Docket Item # 4 BAR CASE # 2009-0290

BAR Meeting December 16, 2009

ISSUE:	Alterations
APPLICANT:	OTW Limited Partnership (Kenneth Wire, Agent)
LOCATION:	431 South Columbus Street
ZONE:	RC/Residential

Figure 3: Proposed Door - Rear Elevation

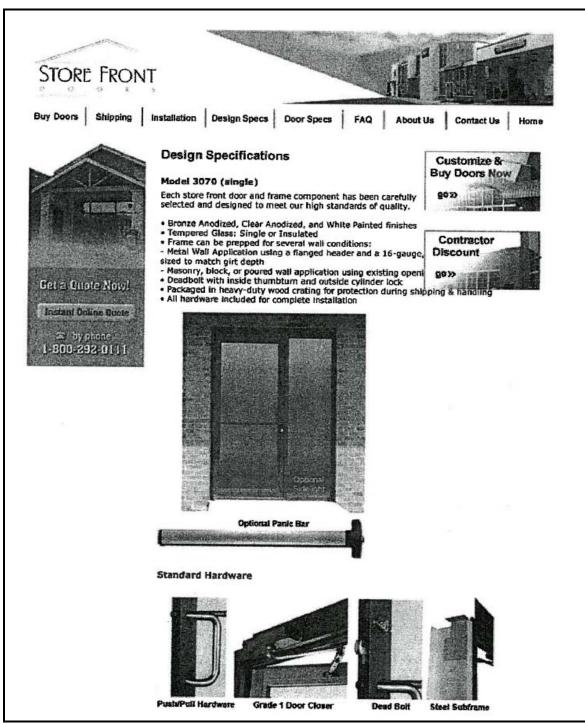
- 1. Replacing an existing, solid metal door (3 feet by 6 feet 8 inches) at the rear of the property with a new single-light, insulated glass and metal door (3 feet by 6 feet 8 inches). The frame color will match the color of the remaining doors on the building and the existing size of the door opening will not be changed.
